# TOWN OF LAKEVILLE MEETING POSTING & AGENDA

Name of Board or Committee:	Planning Board
Date & Time of Meeting:	Thursday, July 27, 2023 at 7:00 p.m.
Location of Meeting:	Lakeville Police Station 323 Bedford Street, Lakeville, MA 02347
Clerk/Board Member posting notice:	Cathy Murray

Mr. Marc Resnick, Town Planner  
Lakeville Planning Board  
346 Bedford Street  
Lakeville, MA 02347

Mr. Marc Resnick  
Lakeville Planning Board  
346 Bedford Street  
Lakeville, MA 02347

**GRADING & DRAINAGE PLAN**

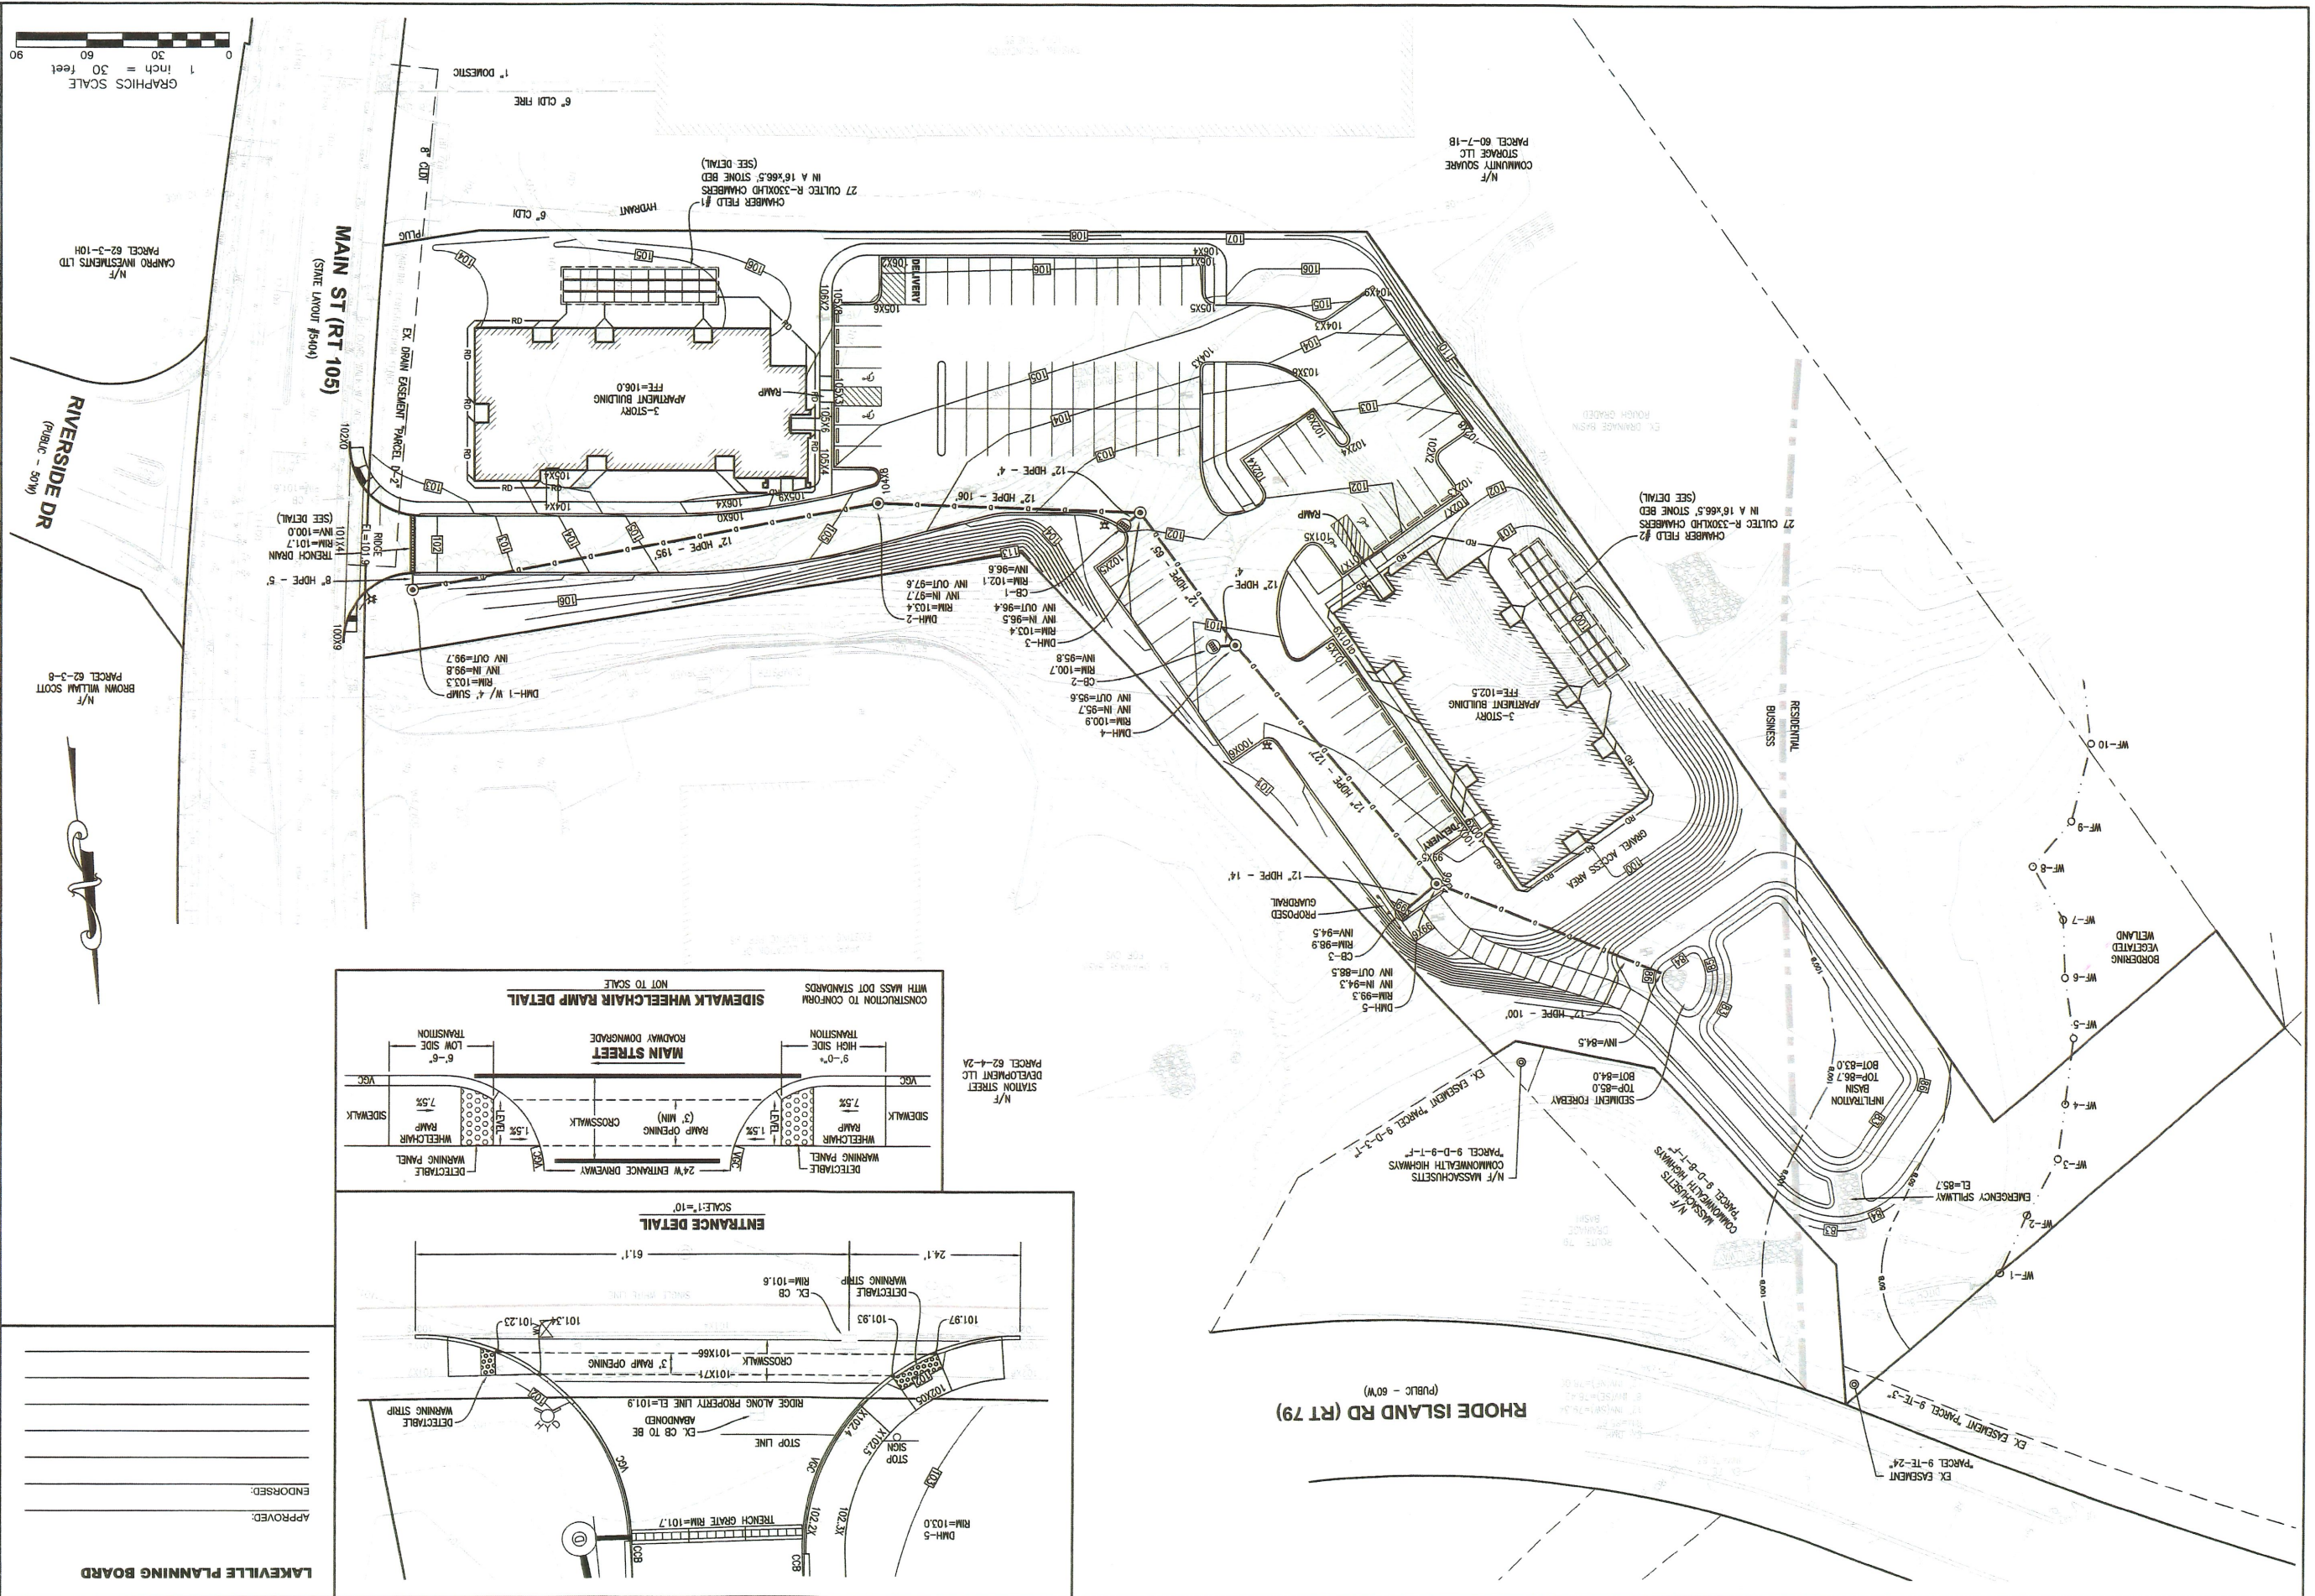
4. The project proposes significant cut across portions of the site (e.g. approximately 18 feet of cut is proposed to the west of the western most 3-story apartment building). The cut areas appear to be in areas where stockpiles of material exist or existed when the topographic survey was performed. We recommend the Applicant quantify the earthwork required for the project as well as the number of trips needed to remove this material if the project requires a net cut.

DATE	PROJECT NUMBER	DRAWING SCALE	N.T.S.	SHEET ID
6-8-23	0454-17-01			D1

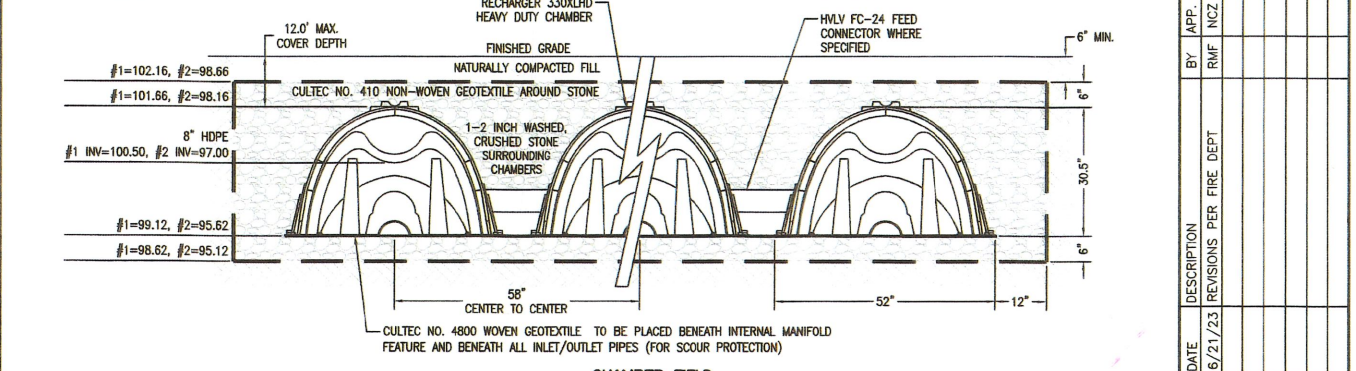
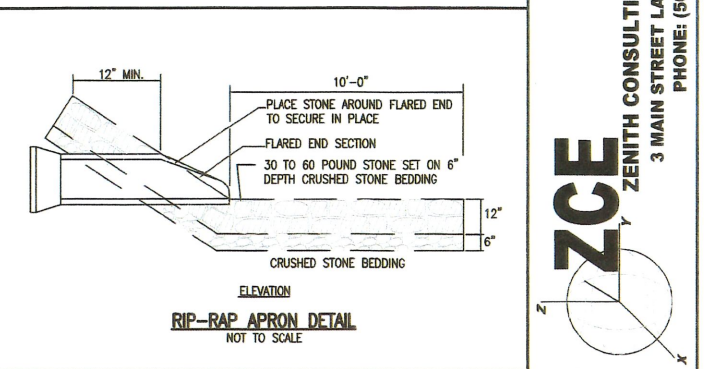
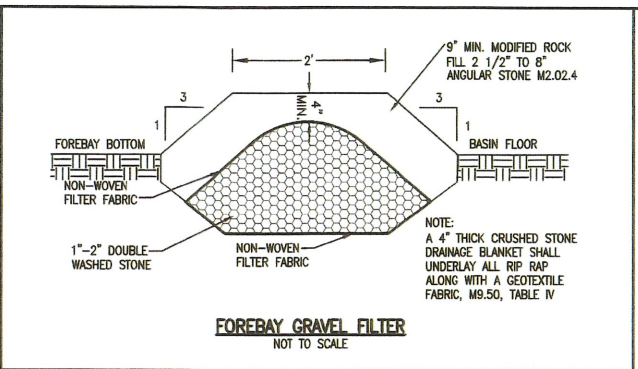
- a. The recharge calculations provided in the Stormwater Management Report indicate that the recharge volume requirements are easily satisfied. However, the Applicant should provide calculations showing that all infiltration facilities are able to drain fully within 72 hours.
